Subject Cleveland Innerbelt Bridge - Utilities - AT&T

Central Viaduct - Pier 12 conflict.pdf

STREET PLAN AND PROFILE
 CENTRAL VIADUCT WAY
 STA. 100+00 TO STA. 103+00

DWG. NO.
 PP-025

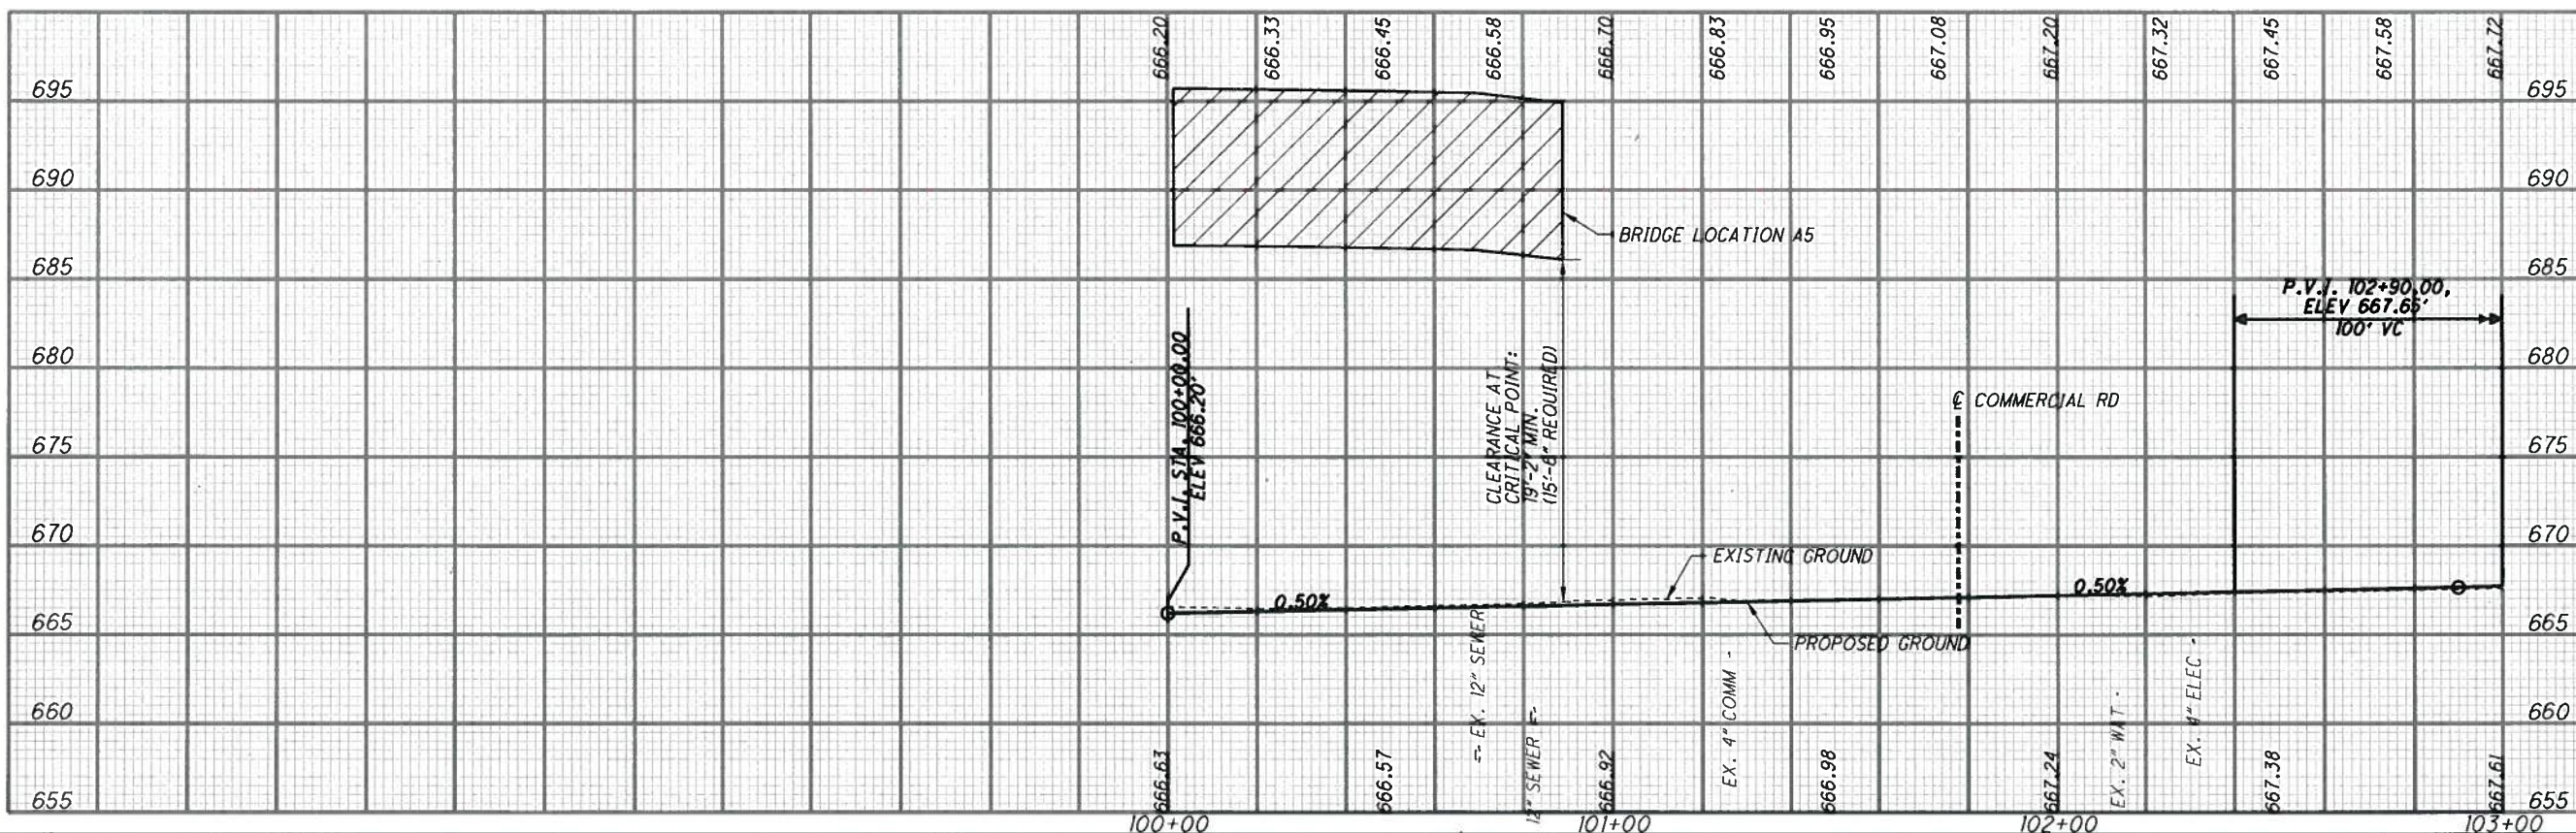
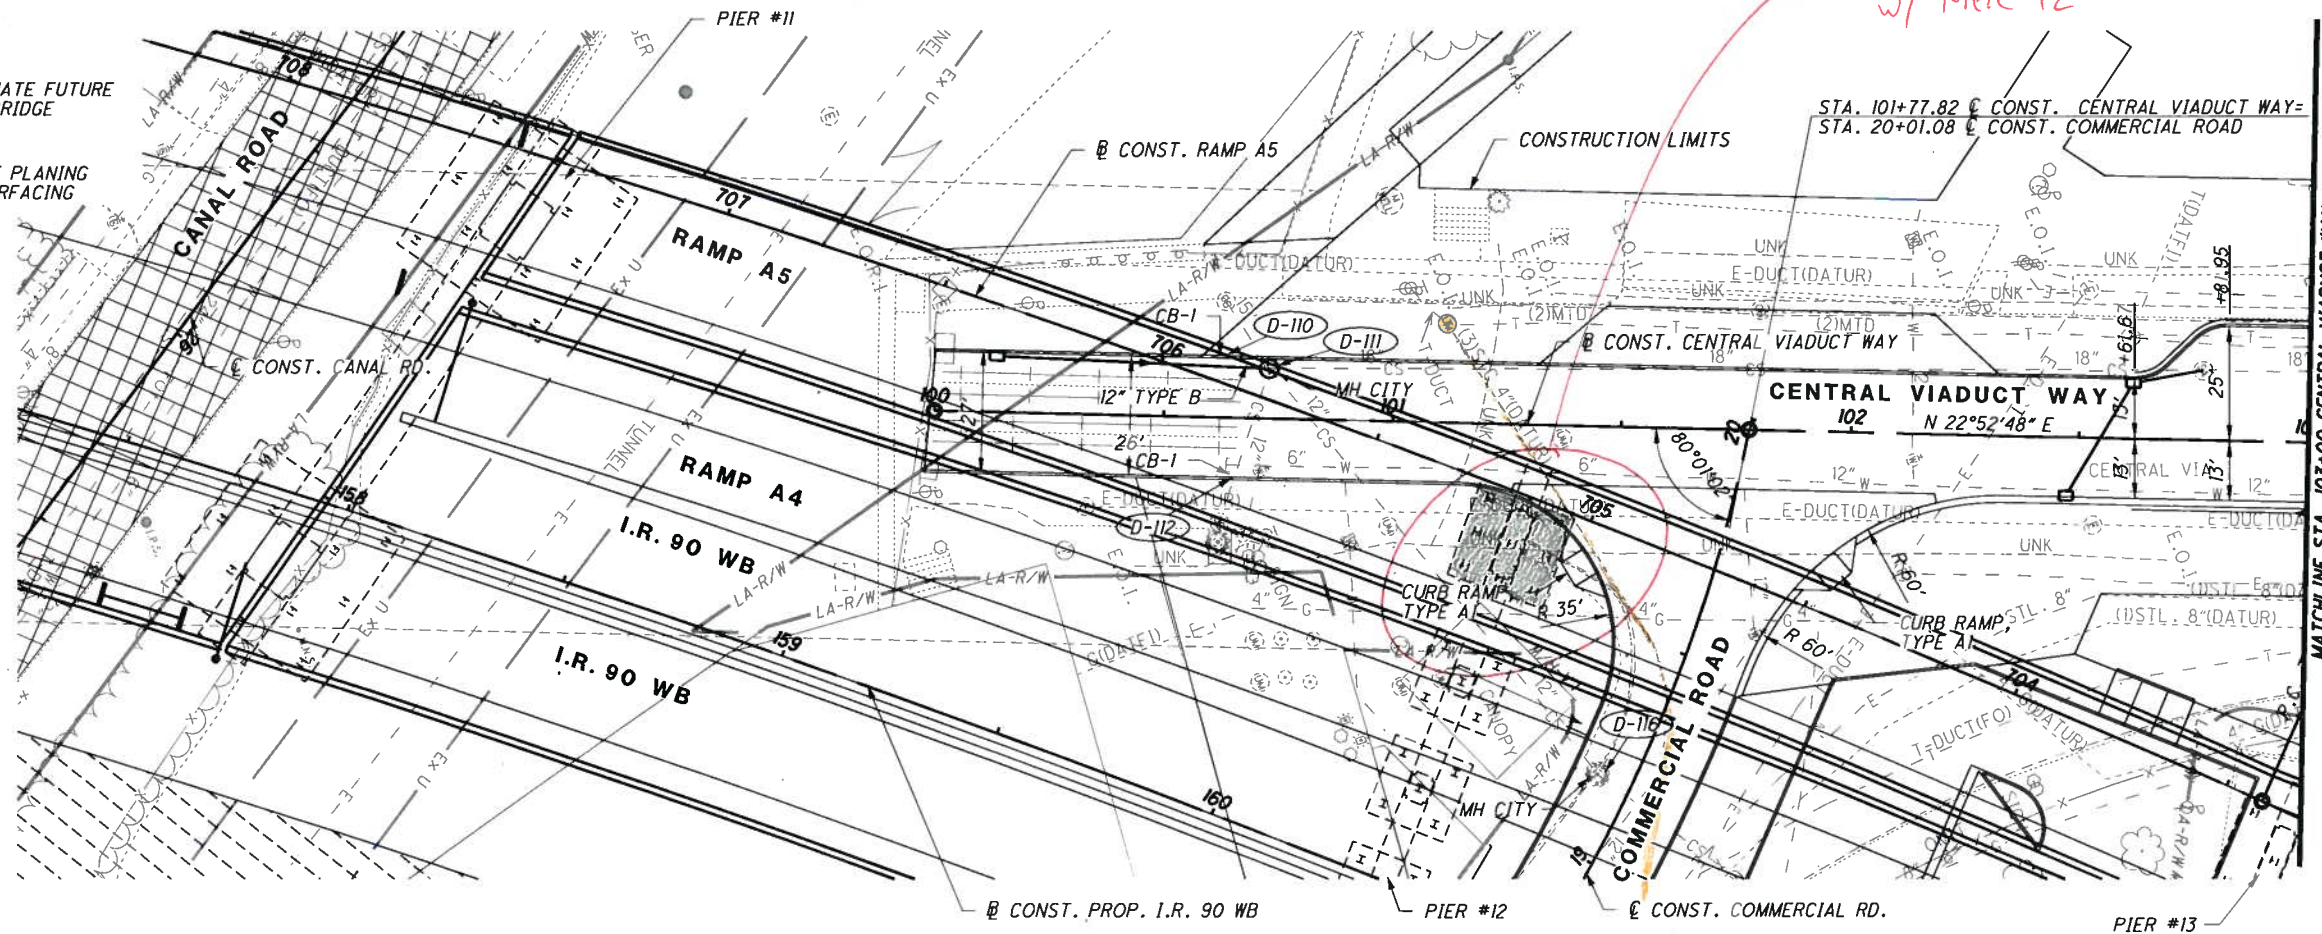
An additional conflict location has been identified. It is at Pier 12 along Commercial/Central Viaduct. This conduit will need to be relocated away from the piers. Call me if you have any questions.
